Application of LMPSF Acquisitions, LLC c/o Troutman Pepper Locke, LLP to rezone property from C-2 (General Commercial) zoning district to HR-1 (High Density Residential – 1) zoning district to allow for single-family, attached and multi-family developments, at 3265 Northeast Expressway.

PETITION NO: N5-2025-0628 Z-25-1247529

STAFF ANALYSIS

CASE NO.:	Z-25-1247529	**File ID #:** 2025-0628
Address:	3265 Northeast Expressway, Chamblee, GA 30341	**Commission District: 01** **Super District:** 07
Parcel ID(s):	18-267-01-003	
Request:	Rezone property from C-2 (General Commercial) zoning district to HR-1 (High Density Residential-1) zoning district to allow single-family, attached, and multi-family developments.	
Property Owner(s):	Reality Income Corporation	
Applicant/Agent:	LMPSF Acquisitions, LLC c/o Troutman Pepper Locke, LLP	
Acreage:	23 acres	
Existing Land Use:	Formally Regal Cinemas	
Surrounding Properties:	**North:** OI (Office Institutional) **East:** OI **South:** MR-2 (Medium Density Residential - 1), R-100 (Residential Medium Lot-100) **West:** C-2 (General Commercial).	
Comprehensive Plan:	RC (Regional Center) __X__ **Consistent** ____ **Inconsistent**

SITE PLAN

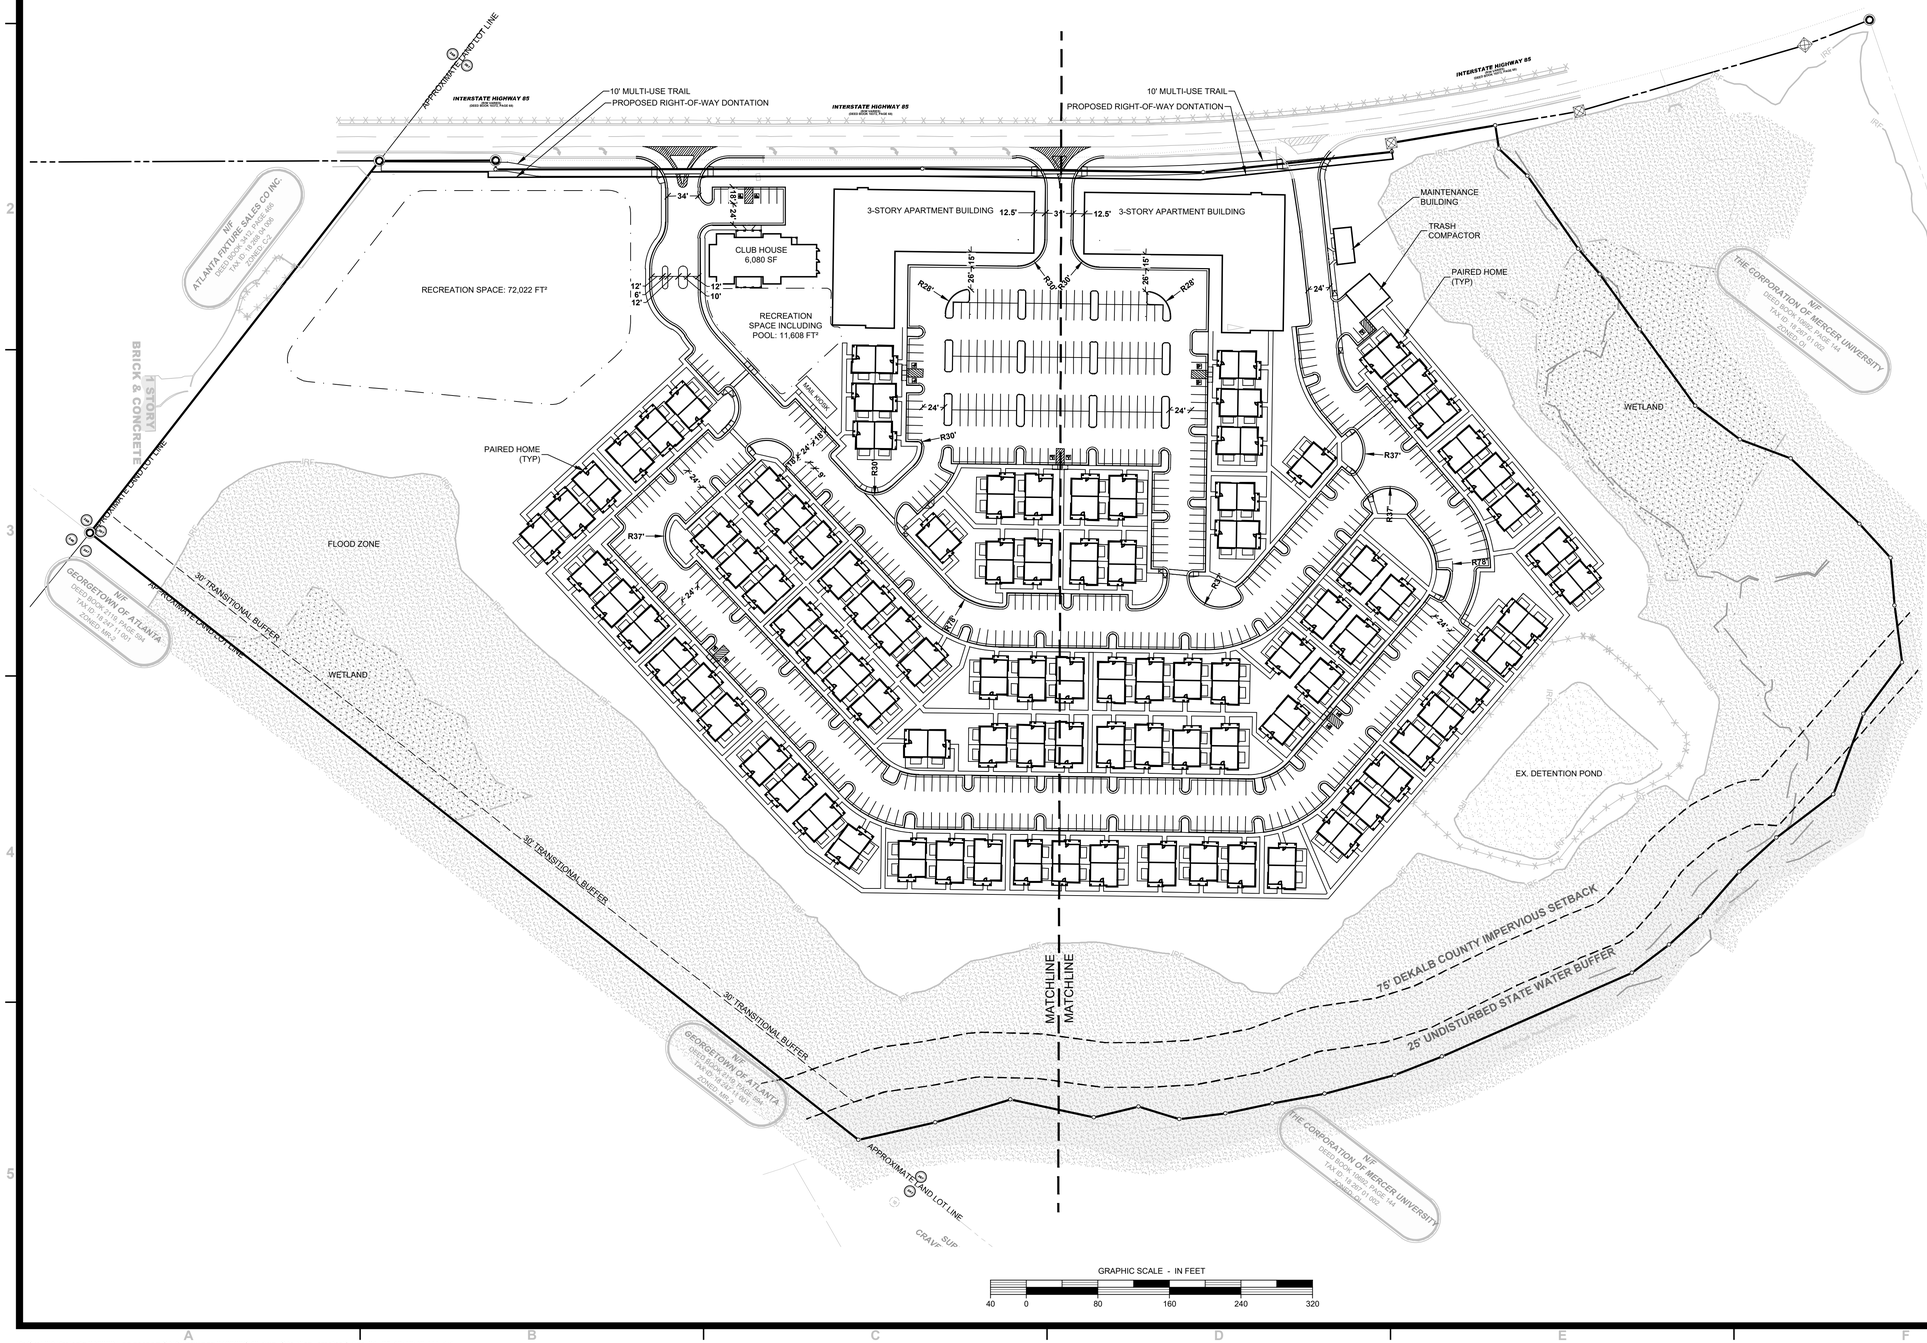
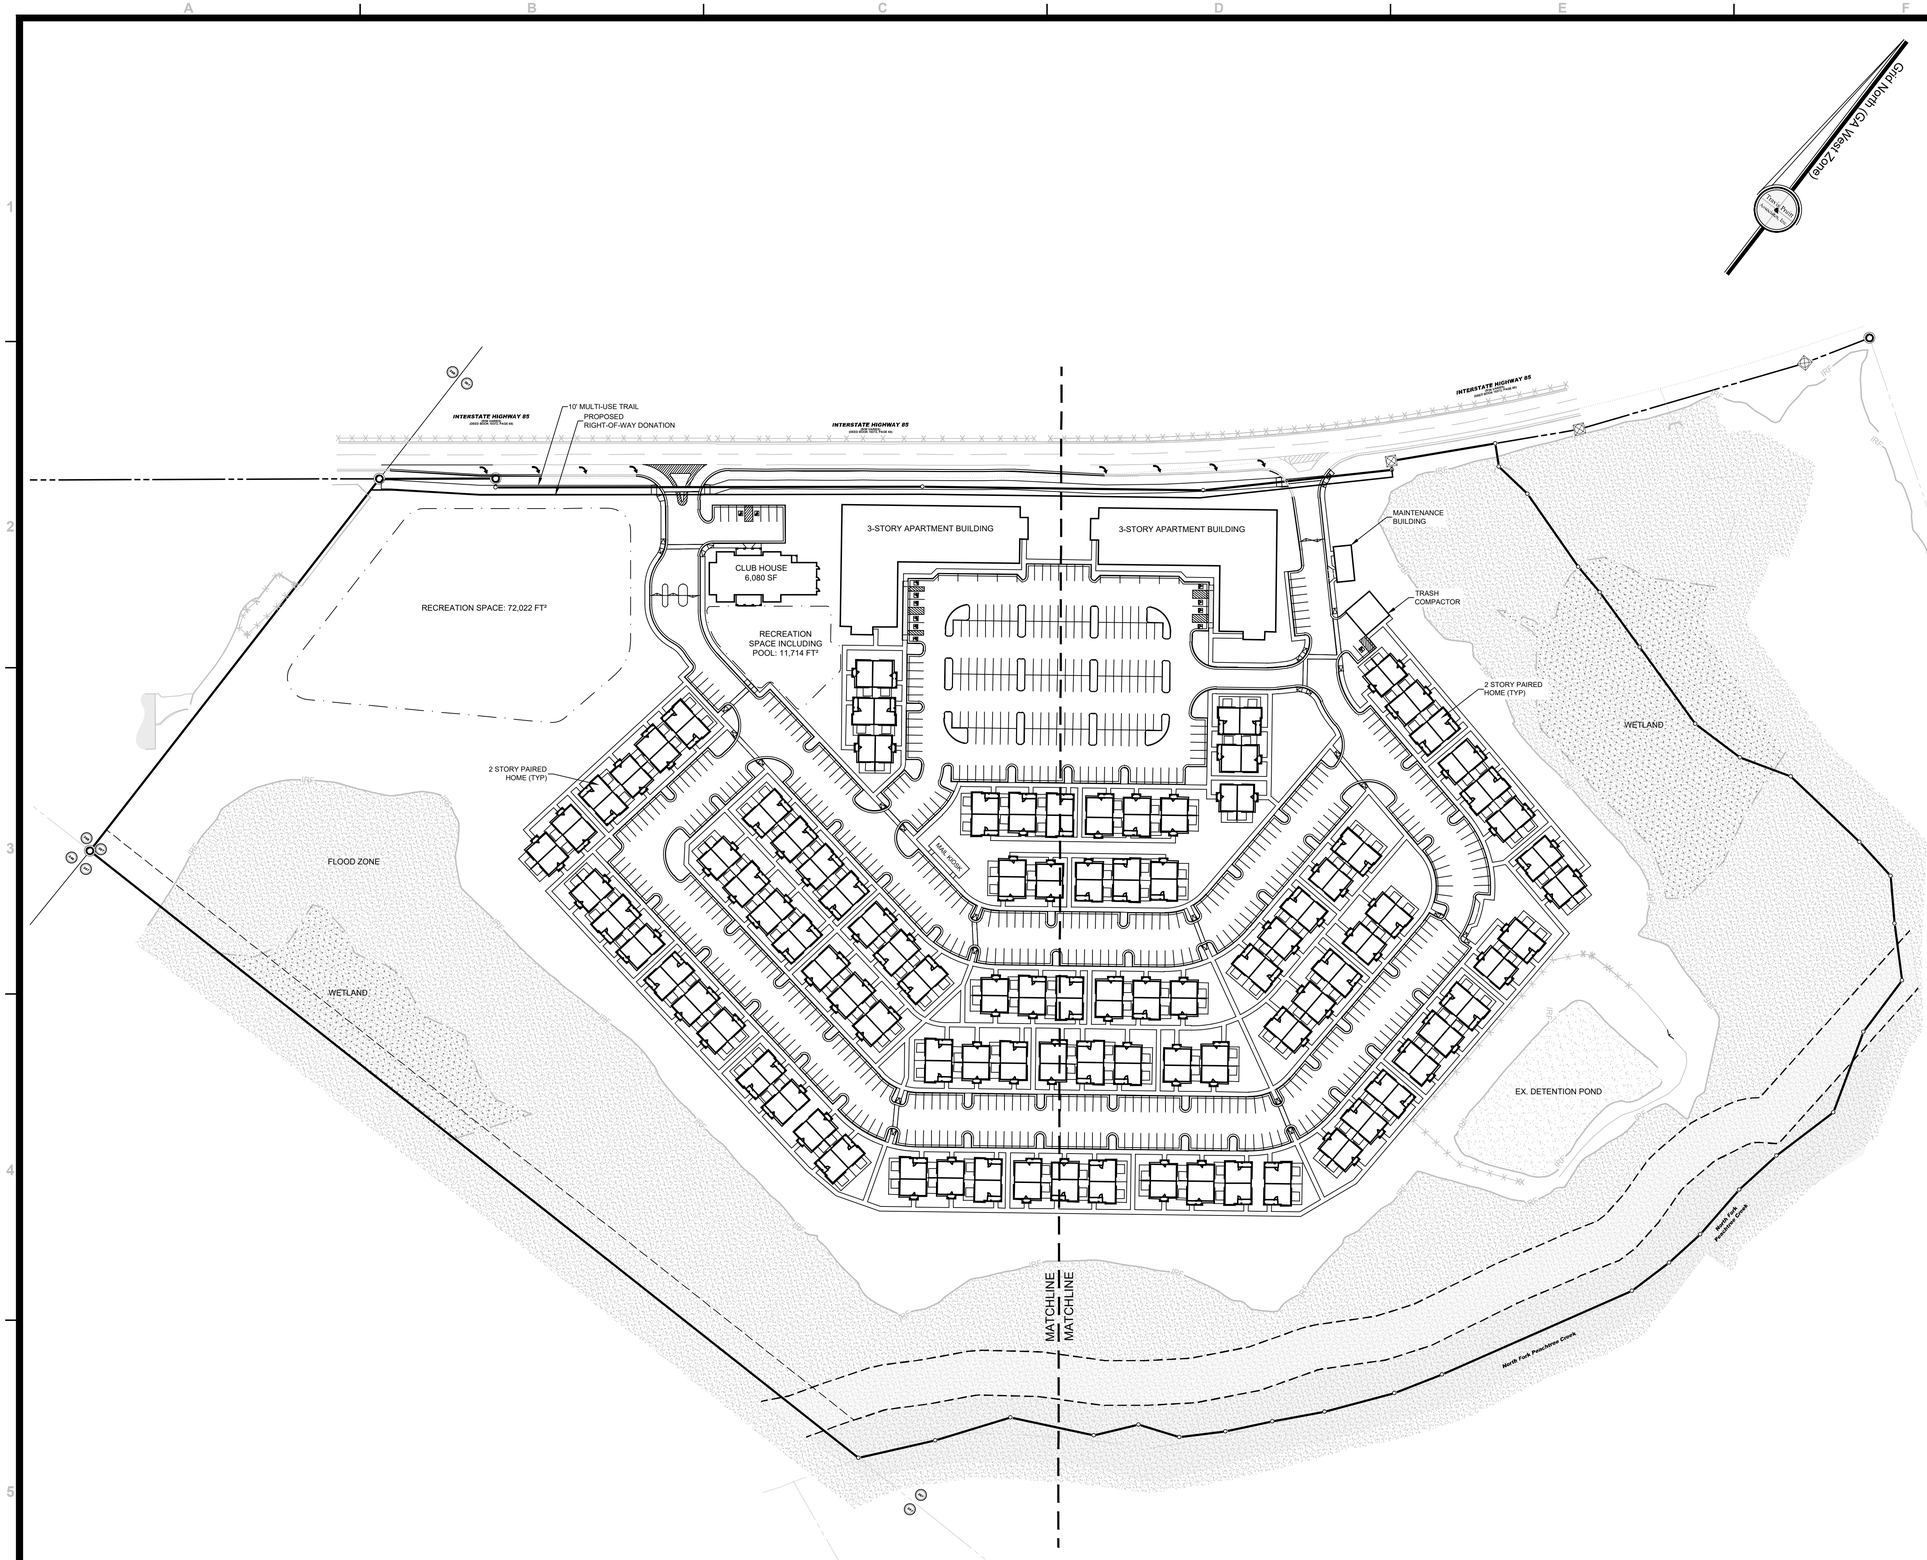
2. The site plan is conceptual; however, the road connectivity and pedestrian walkways shall be maintained or improved. Alterations to the site plan (Everstead at Embry Hills, dated 4/18/25) to better support other compact pedestrian-oriented improvements such as but not limited to, a connection to the "Recreation Park" or enhanced open space around the stormwater detention facilities, are subject to approval of the Planning Director.

2. The site plan is conceptual; however, the road connectivity and pedestrian walkways shall be maintained or improved. Alterations to the site plan (Everstead at Embry Hills, dated 4/18/25) to better support other compact pedestrian-oriented improvements such as but not limited to, a connection to the "Recreation Park" or enhanced open space around the stormwater detention facilities, are subject to approval of the Planning Director.

DeKalb County Parcel Map

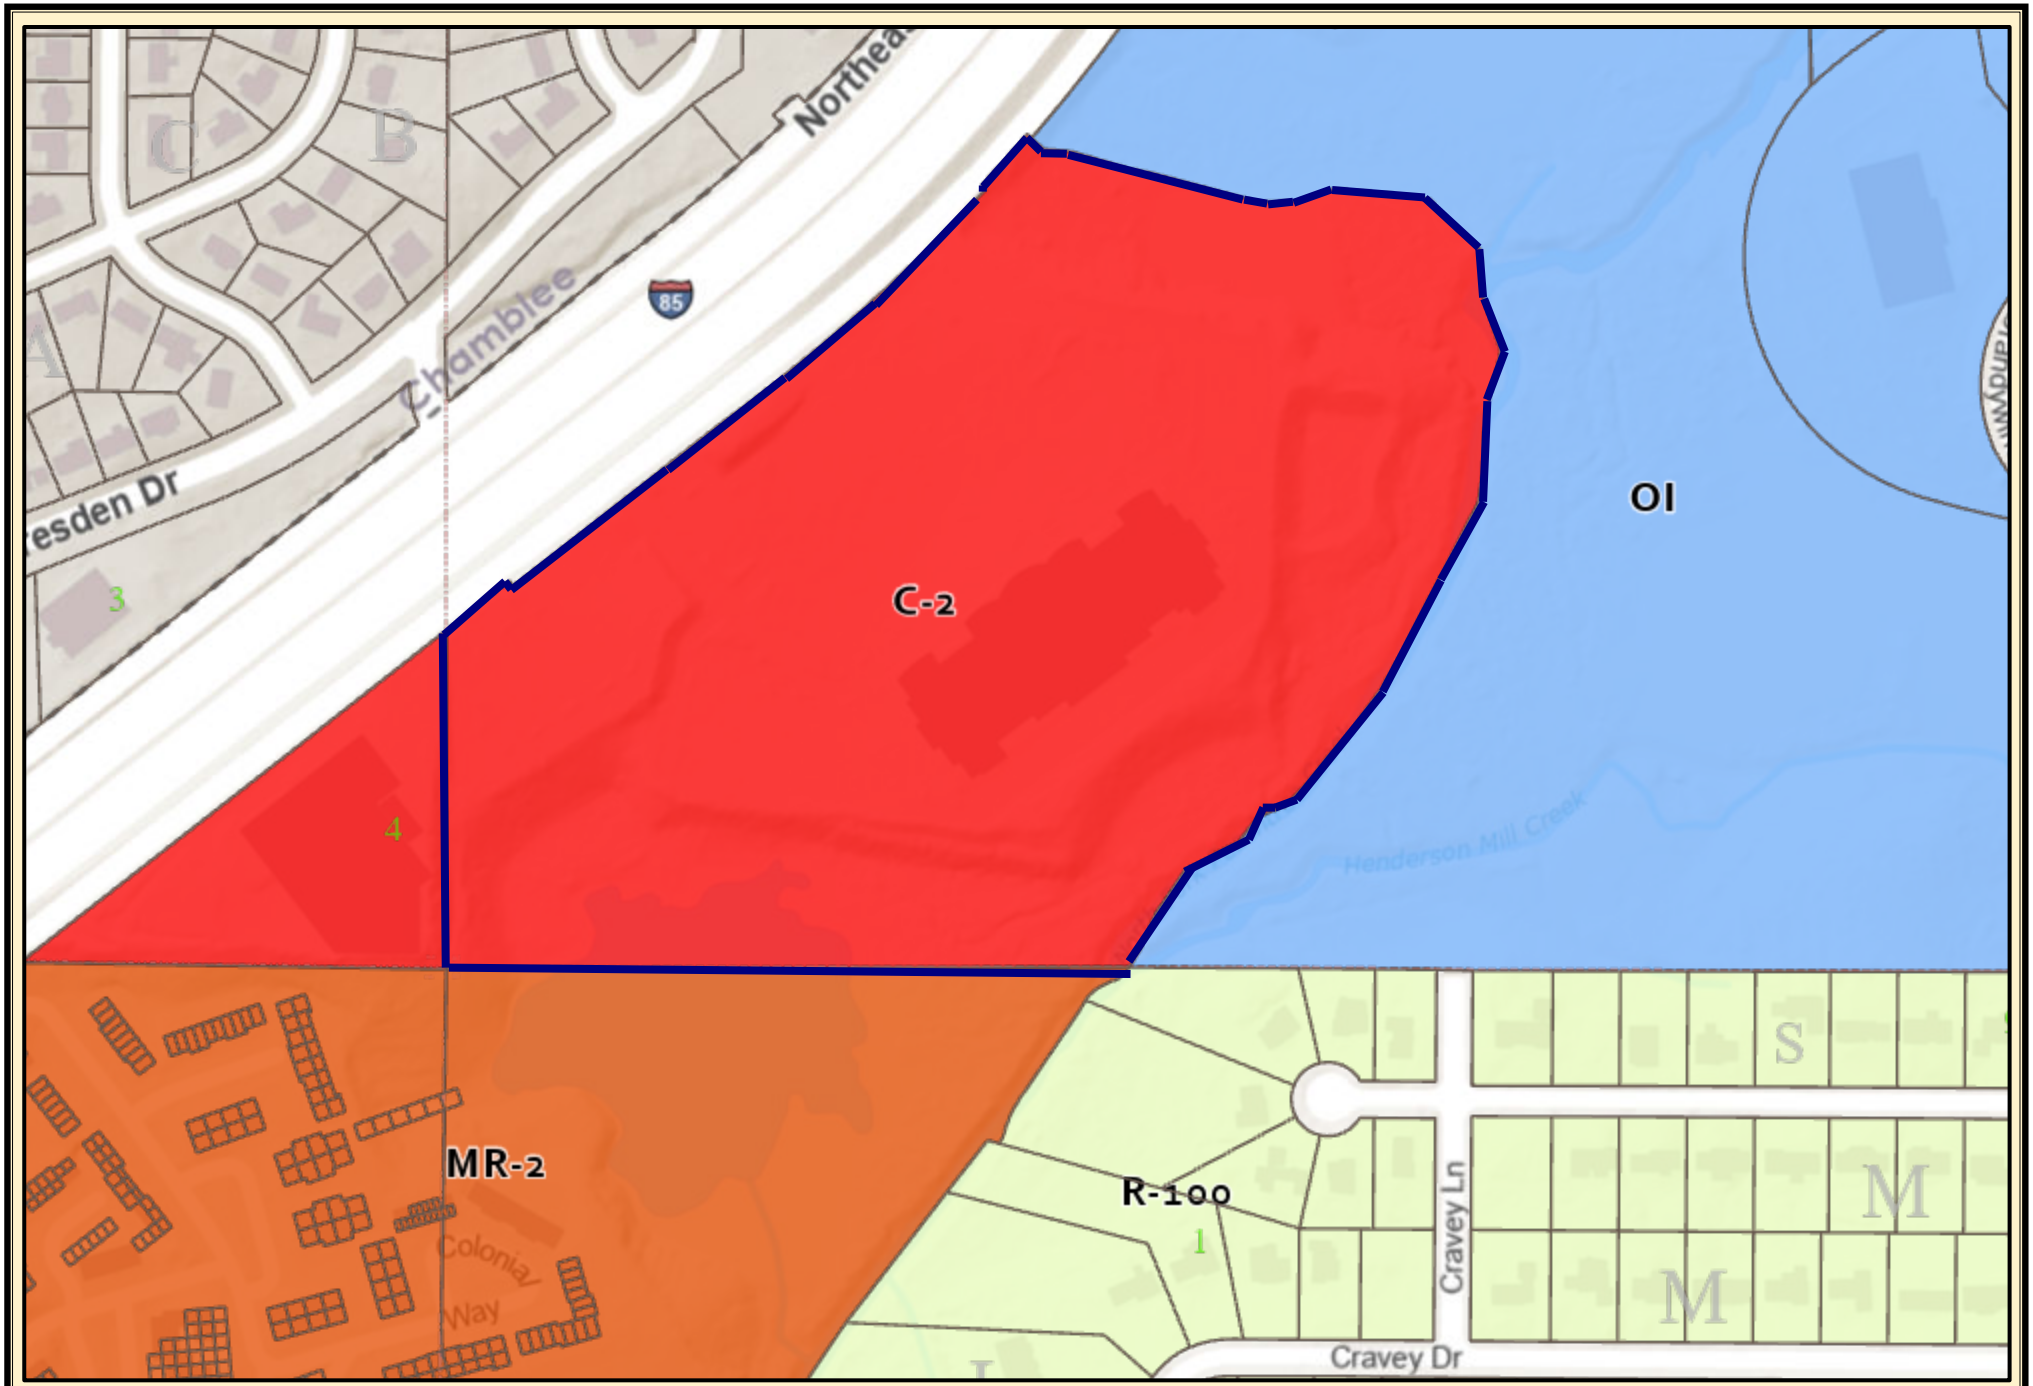
COMMENTS: Property falls within a Regional Center Character area calling for residential densities up to 120 units per acre and building heights up to 10 stories. Verify with Atlanta Regional Commission that Development of Regional Impact is not required. Floodplains areas along three sides of the property. Investigate connecting to Peachtree Greenway. Consider bike parking, dog parks, altervative fuel vehicle parking. While this property is not within a Small Area Plan, the abutting property to the south is within a Small Area Plan--please review to see what impacts it might have on proposed project Accessory commercial is encouraged to support the Regional Center Character Area calling for high density mixed use. HR-1 allows a maximum base density of 24 units per acre, with up to 40 provision of density bonuses. 30 foot transitional buffer required where abutting MR-2 zoning to sc Last day to hold community meeting with 15 days notice is 4/14/25 and filing deadline is 4/21/25. Review comments are preliminary only; final review comments will be made when an official application is submitted. Where is detention being provided.
